October 29, 2015

Re: Assessment of Soccer Fields

South Field

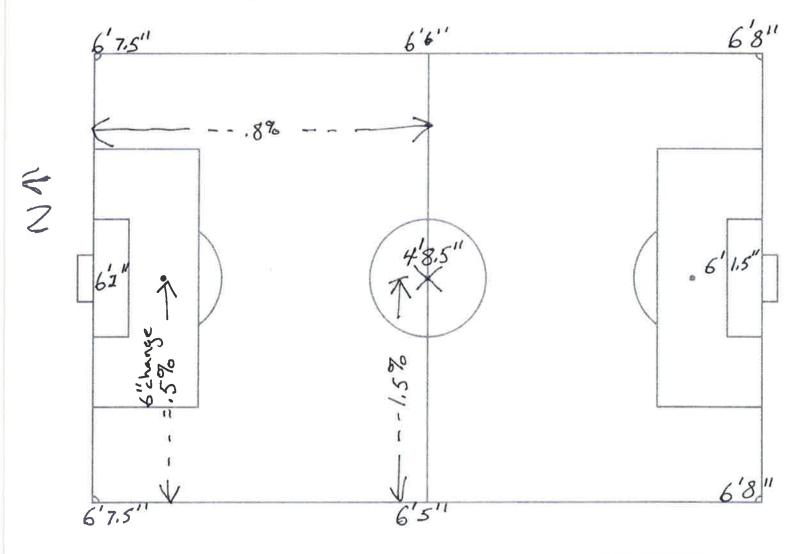
field to the South end the grade starts to pitch toward the South West corner. Both end lines have irregularities that go beyond the tolerances but do not create an unsafe situation. The South Field is an Engineered, native soil, surface drained field. Sideline to sideline grade at mid field is 1.5%, at both end lines it is .5% and from mid field to each end line .8%

- Station Placed at mid Field (X)- 5et to 48.5"

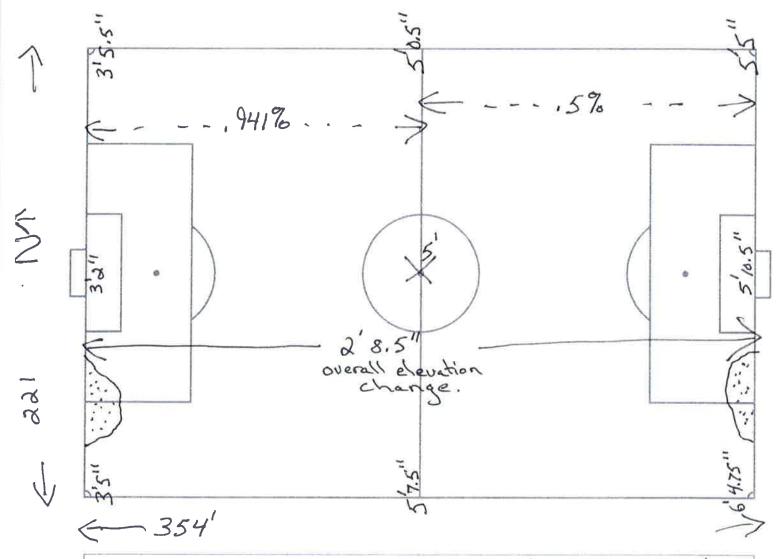
- Both fields are safe for competitive use and have good turf density. Weed coverage on either field is low.
- The grade on the North field is in a North to South direction and is approx. 0.5% slope from the North goal to mid field, and 0.94% from mid field to the South end. Overall the South end is approx. 2 ft. 8 inches lower than the North end, this was elevation is based on the middle of each goal, on the goal line. From sideline to sideline the north end line is consistent. From mid

- Station Plaked at mid Field (X)-set to 5'
- higher # means lower elevation

- (iiiii) irregular grade areas

- South East Corner is higher than mid field.

PRELIMINARY SOCCER FIELD LAYOUT WHEATLAND-CHILI

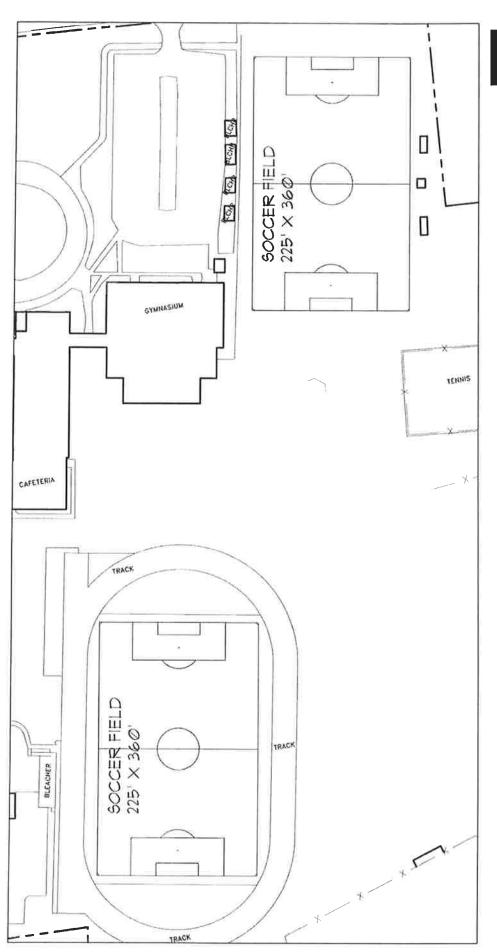
Our field efforts Friday afternoon essentially confirm Pete's preliminary sketch (attached). Our findings are as follows:

- Soccer field along North Rd. measures 354' long. Width is unknown as it is not striped.
- Soccer field within the track is partially striped and measures 223' wide x 356' long.
- The maximum size field recommended by the National Federation of State HS Associations is 225' wide x 360' long (also attached).

NOTE: THESE MEASUREMENTS WERE TAKEN FROM OLD DRAWINGS AND THERE MAY BE DISCREPANCIES IN ACTUAL DIMENSIONS, THESE ARE THE BEST AVAILABLE AT THIS TIME
